COLORADO
Division of Reclamation, Mining and Safety
Department of Natural Resources

Re: Kilgore Companies, Inc.; Peak Ranch Resource; M2020-041;
Notice of Objections to Construction Materials Regular (112) Amendment Application

Figure 1. Example of vegetation zones that develop on a reclaimed lake shore with varying gentle to steep slopes. Shorelines with healthy littoral and riparian zones provide many benefits to wildlife and to water quality. (from MDNR 2012)

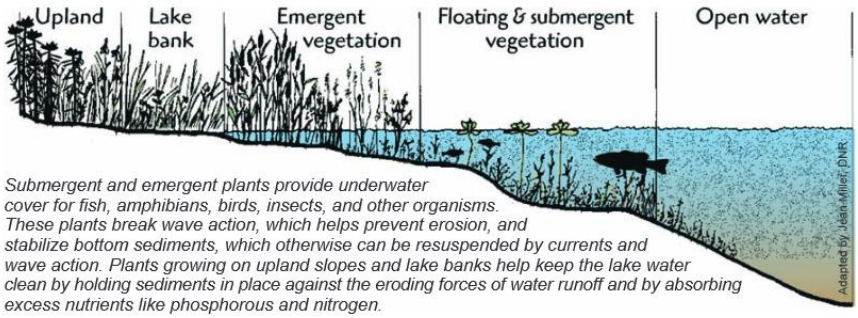
As planned, the shoreline of this pond is starkly uniform. The entire pond will be enclosed by steep 3H:1V mined slopes both above and below the water line. (Exhibit F – Final Reclamation Plan, Map F-1) This design will accommodate only extremely narrow zones suitable for emergent and bank vegetation. Physical diversity, in this case variable and gentler slopes, is necessary to promote desirable vegetation growth and encourage greater connectivity with the existing riparian vegetation along the Blue River and thus provide real benefit to local wildlife. (Figure 1, below)

The permit application includes a further deficiency: in addition to uniform slopes, the pond perimeter is nearly rectangular, broken up by a perfunctory bit of decorative "scalloping" along the northeast corner. Rule 6.3.4(1)(d) plainly requires that where "wildlife habitat is the proposed future land use, shorelines should be irregularly shaped to promote a diverse wildlife habitat."

Recommendations: If a "reclaimed" pond is a component of an approved permit application, it should be redesigned to ensure it provides public benefit: for wildlife and/or recreation. A regrading plan should be developed and implemented that will result in varying shoreline slopes,

both above and below the waterline, and promote shoreline vegetation that will provide habitat for insects, fish, amphibians, and birds. The applicant should be further encouraged to take this opportunity to redesign the perimeter of the pond to be more irregularly shaped from its current poorly disguised rectangle.

Figure 2. Potential wetland resources located on the PRR property.

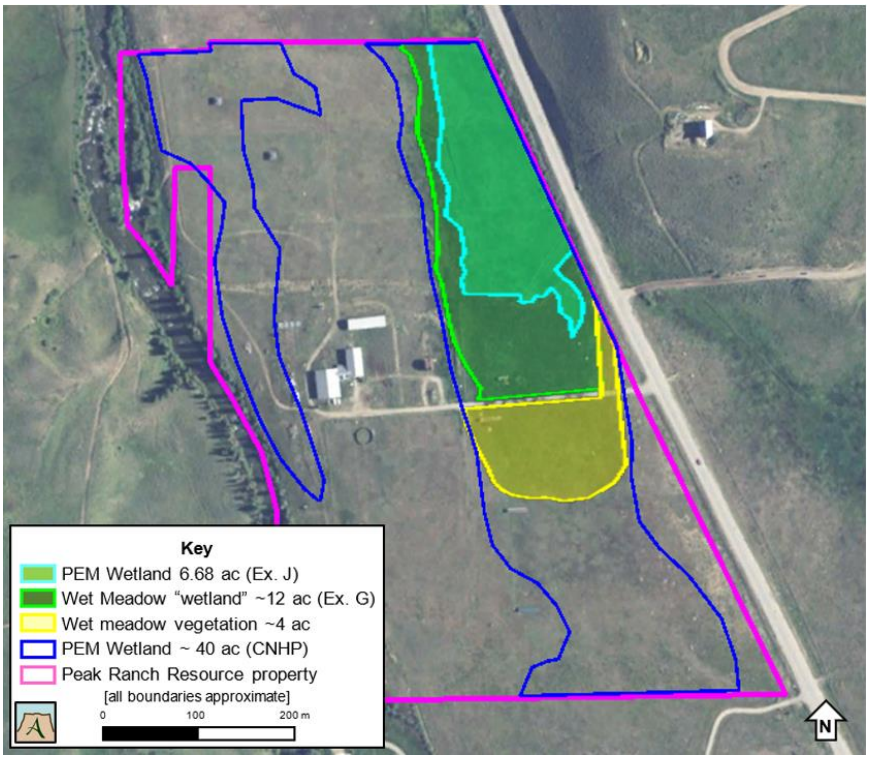
In contrast, in Exhibit G – Water Information, a larger proportion of the Rocky Mountain Alpine-Montane Wet Meadow vegetation community is characterized as "wetland area" (Figure 2, below). No additional information is provided as to how this approximately 12-acre wet meadow "wetland" was determined.

In aerial imagery, as well as on the ground, the wet meadow vegetation can be observed to extend further south than indicated even in Exhibit G, increasing the potential for wetland resources on site to exceed 16-acres (Figure 2, below). Additional resources indicate that historical wetlands may have covered at least 40-acres of this property. (CNHP 2020; see also Figure 2, below)

Depending on the full extent of jurisdictional wetlands found on this property, the areal extent of wetland resources that will be directly impacted by the proposed mine, haul road, and berms ranges from less than 0.1-acres to over 10-acres.

<u>Recommendations</u>: It is imperative that the actual extent of the wetlands on the property is independently confirmed by the US Army Corps of Engineers before this application can be deemed complete and adequate. The applicant also needs to revise and complete Exhibit J and provide DRMS and other interested parties all of the Wetland Determination Data Forms used in the wetland delineation described therein.

Figure 1
Hillyard Property
Lower Blue River
General Location Map

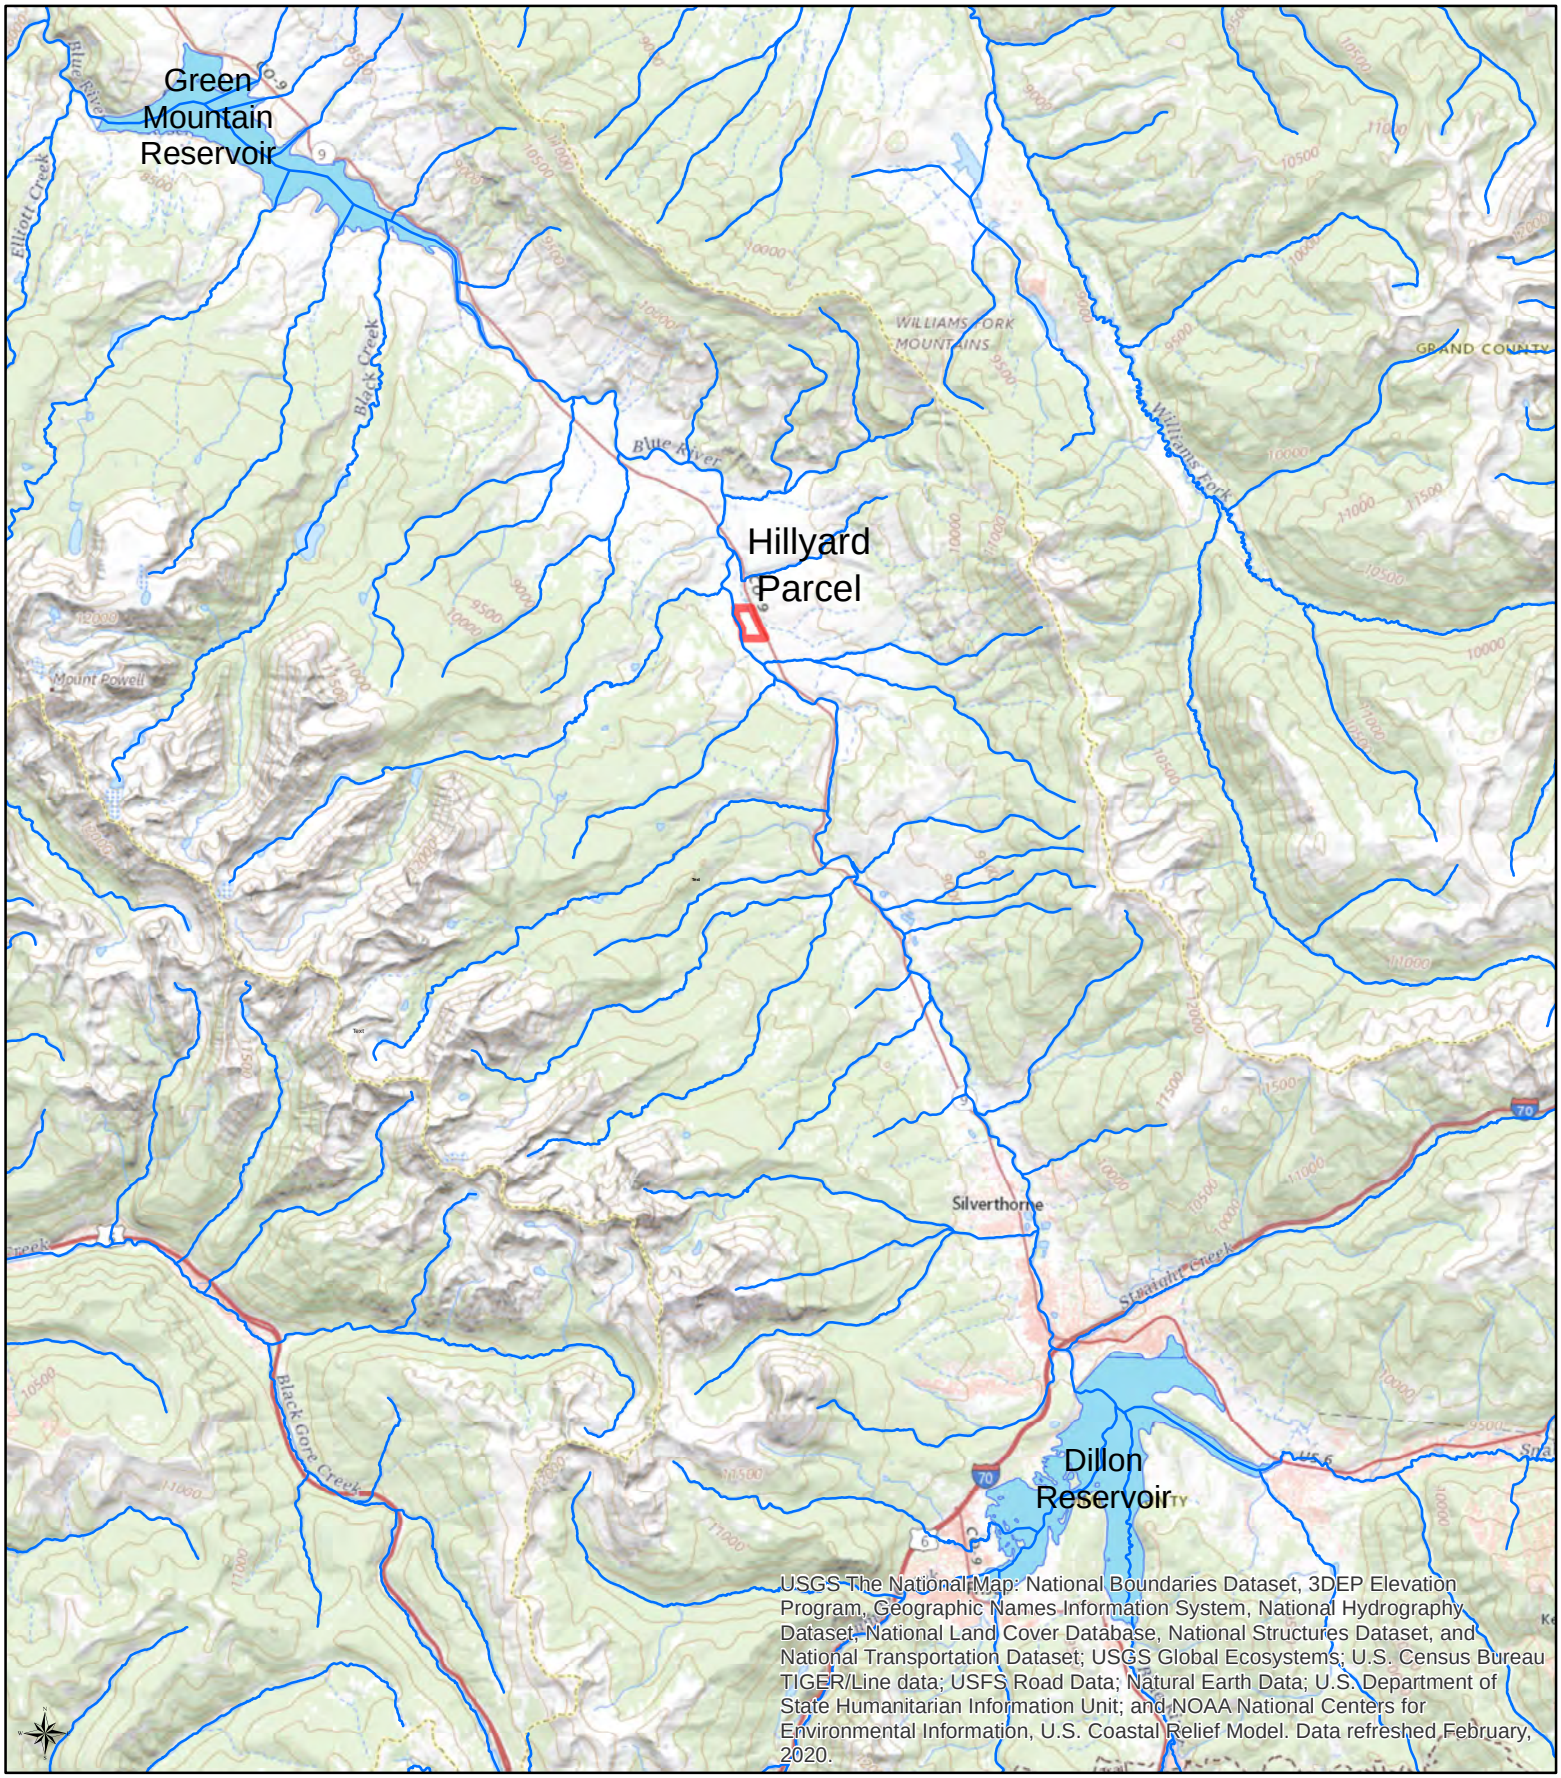
The Hillyard parcel is comprised of four parcels each approximately 20 acres in size. The parcel also shares a boundary with a portion of the White River National Forest. Figure 1 shows the approximate location of the Hillyard parcel including Dillon Reservoir and Green Mountain Reservoir, for reference. Figure 2 shows the general location of the Hillyard Property with nearby streams including Acorn Creek to the south and Slate Creek to the north.

Figure 3
Hillyard Property
Lower Blue River
Measured Wells

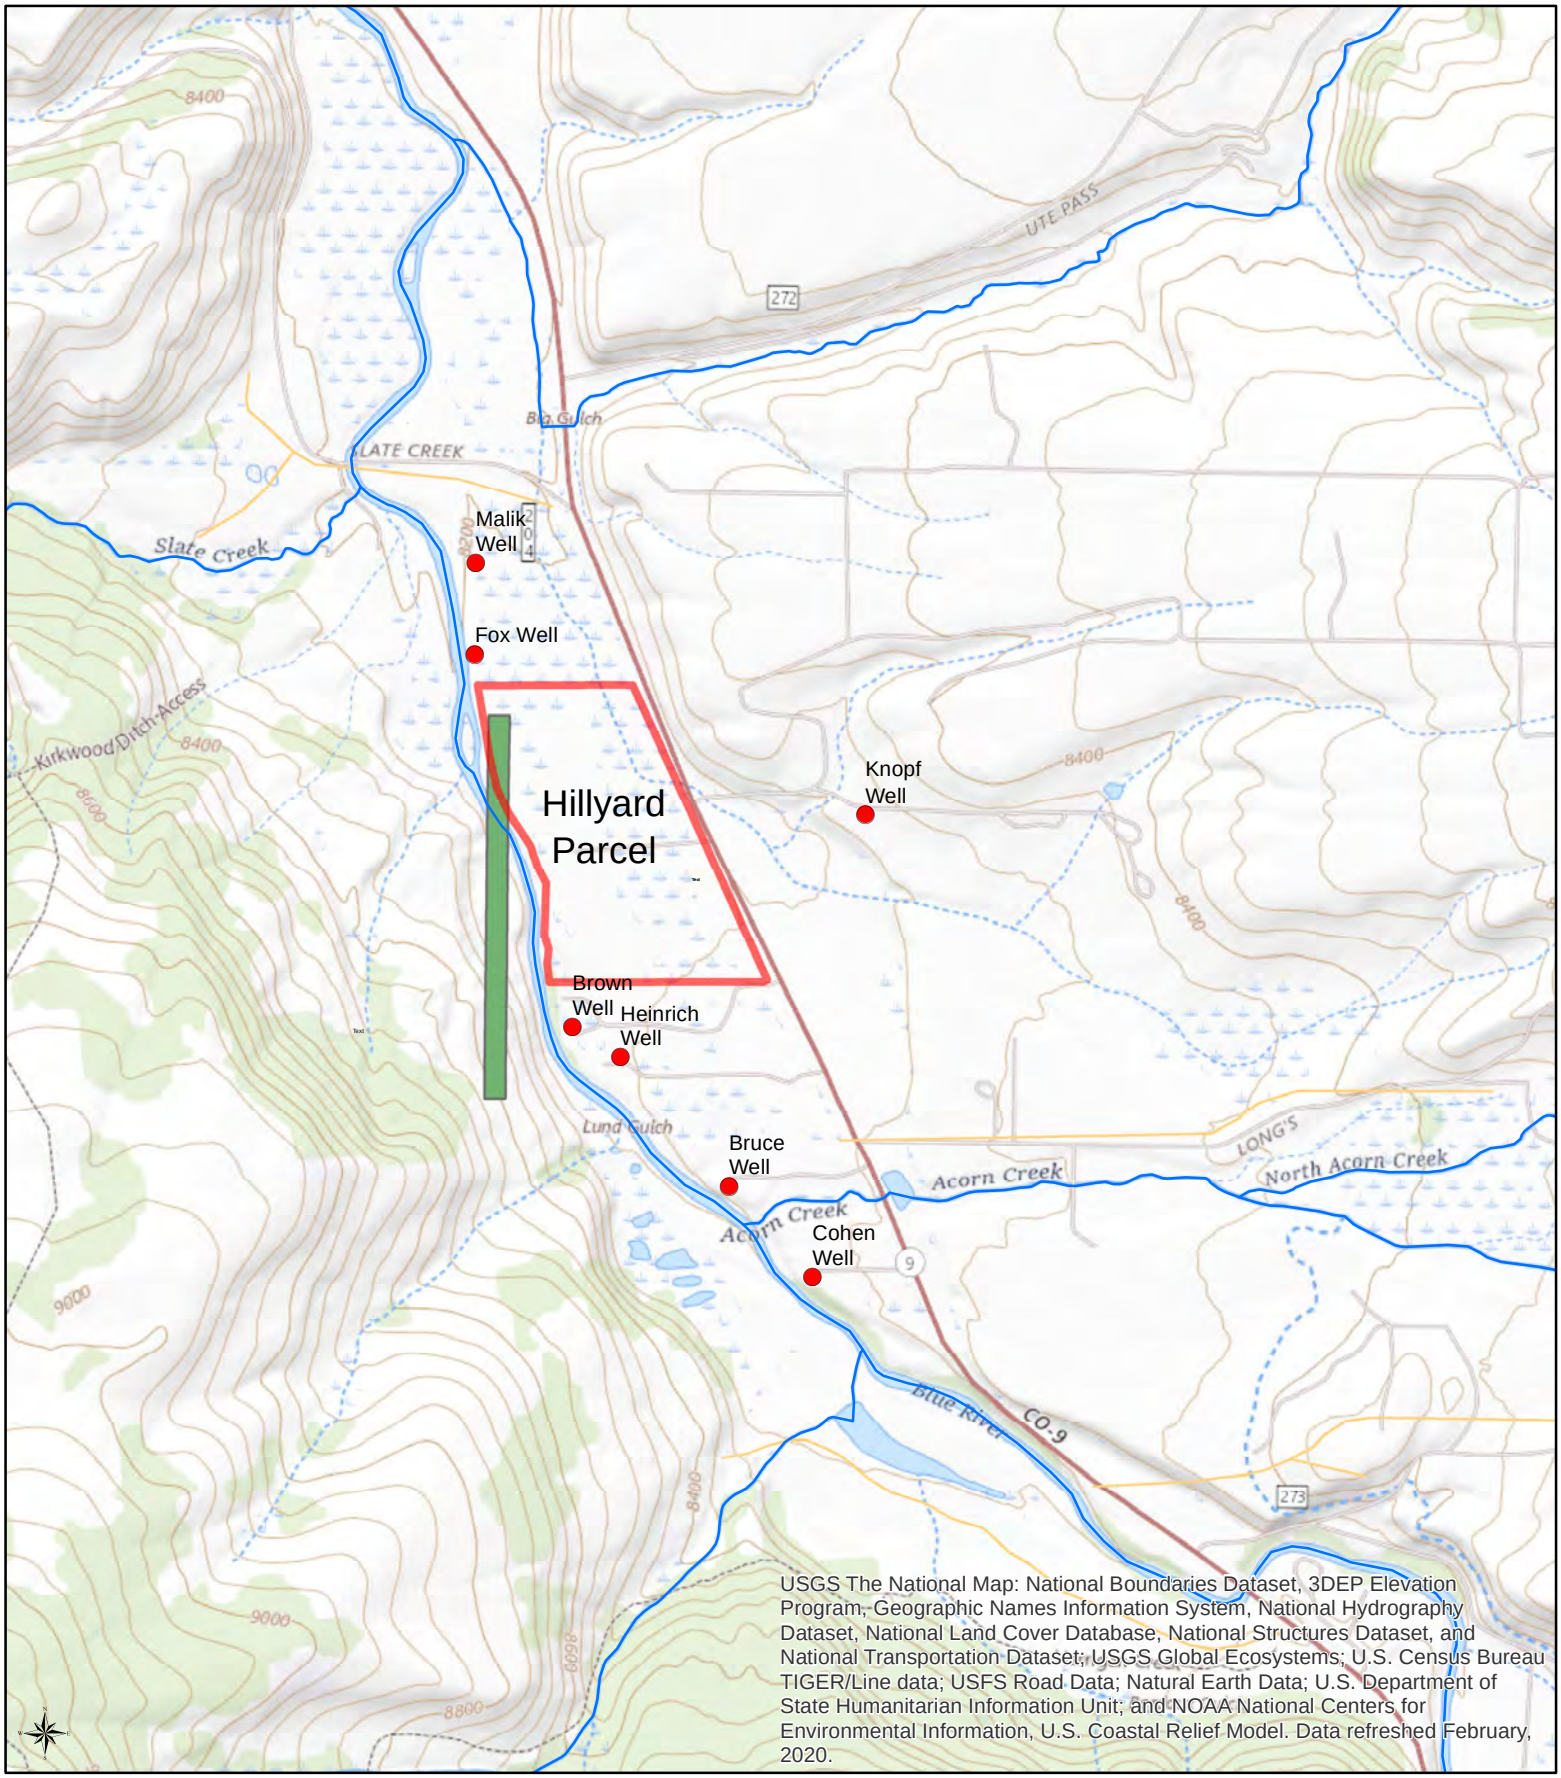
There is high groundwater in the area underlying the Hillyard Property. Groundwater levels in nearby wells were measured at various times in 2019 and 2020. The depths to groundwater are shown in Table 1, attached. The locations of the wells in which water levels were measured are shown in Figure 3.

Figure 4a
General Aquifer Characteristics

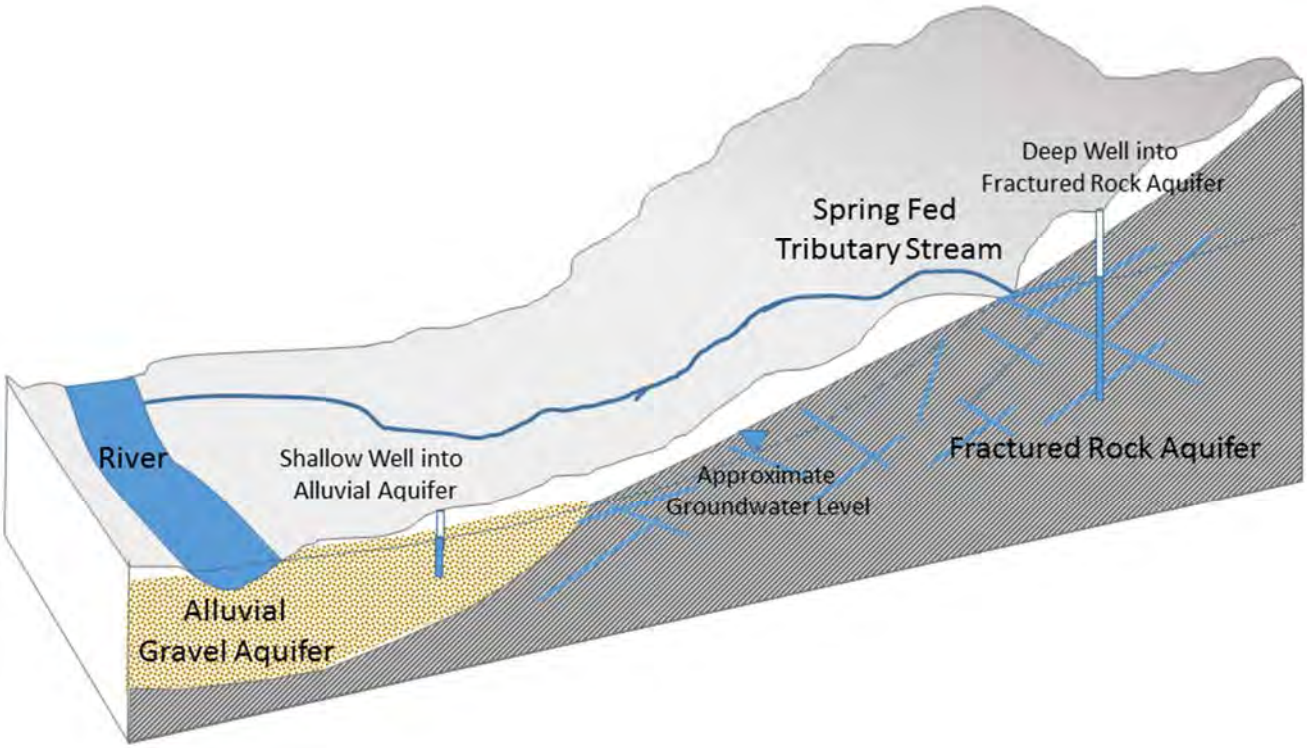
From our research of geological features in the area, it appears that the uphill aquifer is a fractured rock system, with flow paths that can quickly move water out of the fractured rock system to the gravel alluvial aquifer in the valley below. A general schematic depicting the aquifer characteristics in the area is attached as Figure 4a. Figure 4b demonstrates a potential gravel pit in the area.

Figure 5
Hillyard Property
Lower Blue River
Water Rights

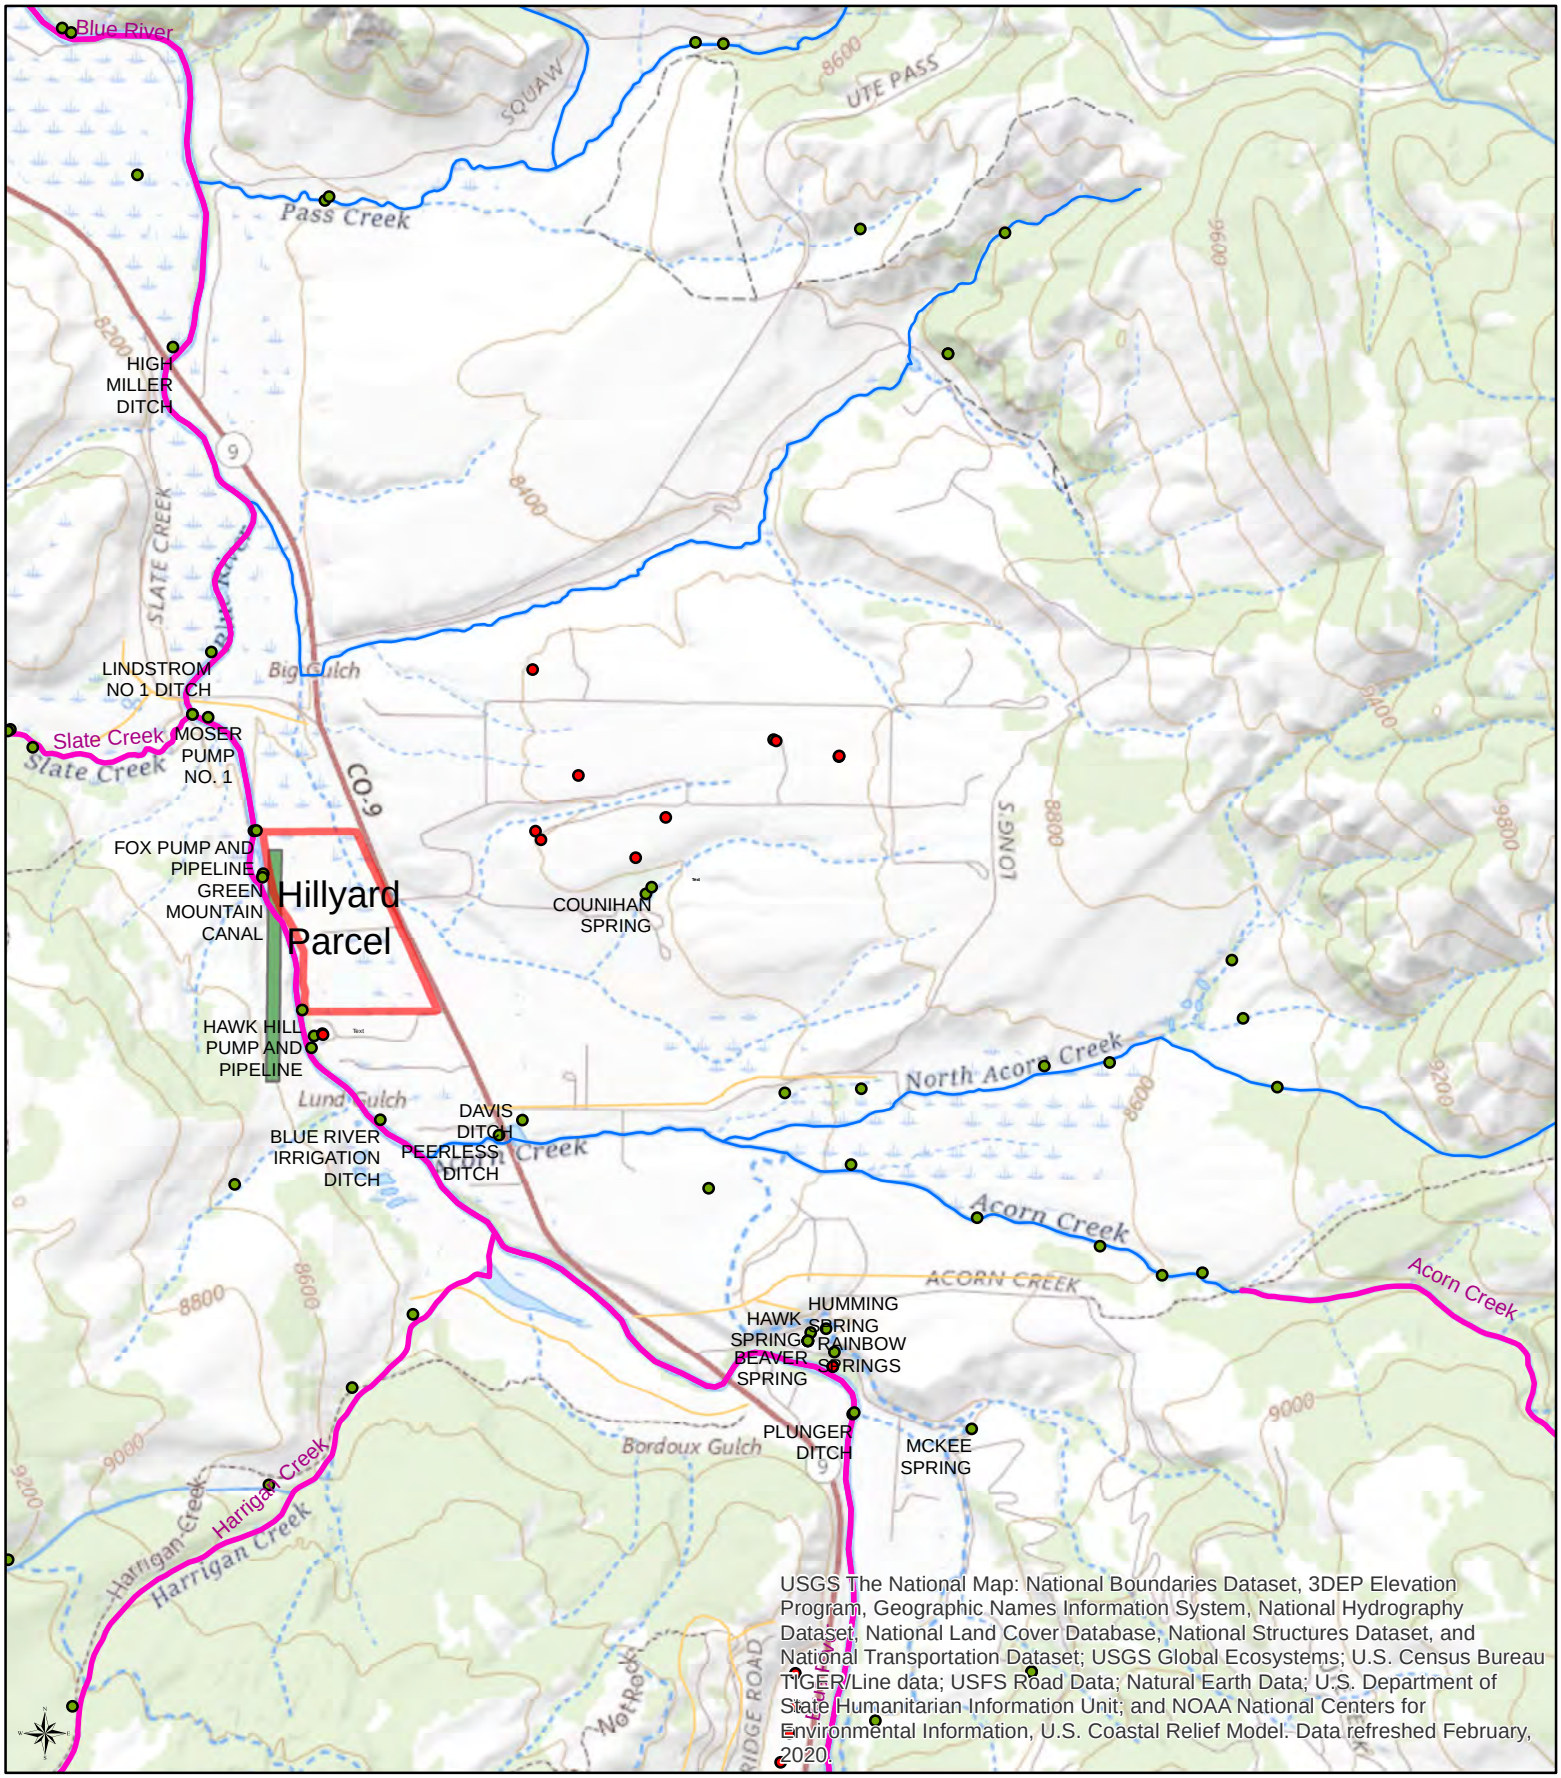
A summary of the water rights and instream flow water rights near the Property are shown in Table 2. Figure 5 shows the location of some of these water rights.
